Wednesday 21 July 2004

**BWEA Reponse: Grid Code Consultation H/04 - Grid Code Changes to Incorporate New Generation Technologies and DC Inter-connectors (Generic Provisions)**

Figure 1: Possible voltage duration profile for which power park module should remain connected under Grid Code proposals.

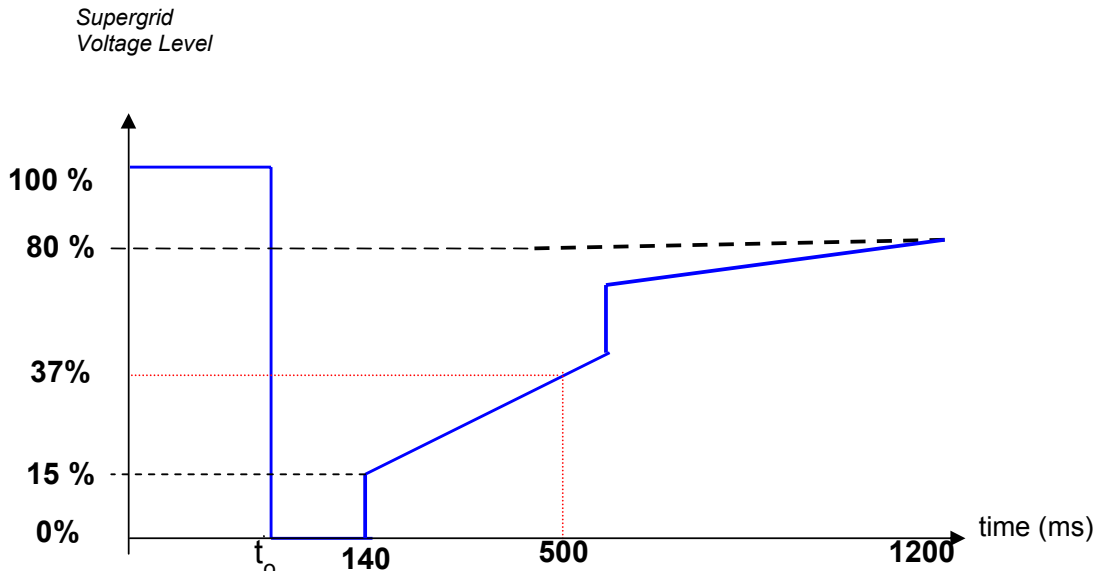
There is also no mention of what the requirement would be in the scenario described in Figure 1 below where the supergrid voltage has not recovered to 90% within 500ms of the fault occurring.

The characteristic in Figure 1 is within the voltage duration profile specified for which a power park module should remain connected, however considering the situation below at 500ms after the fault, surely it would be better for a power park module to disconnect rather than continue to draw MVAR from the system and further depress system voltage, or alternatively, avoid having to provide significant voltage compensation equipment to remain connected under such a scenario.
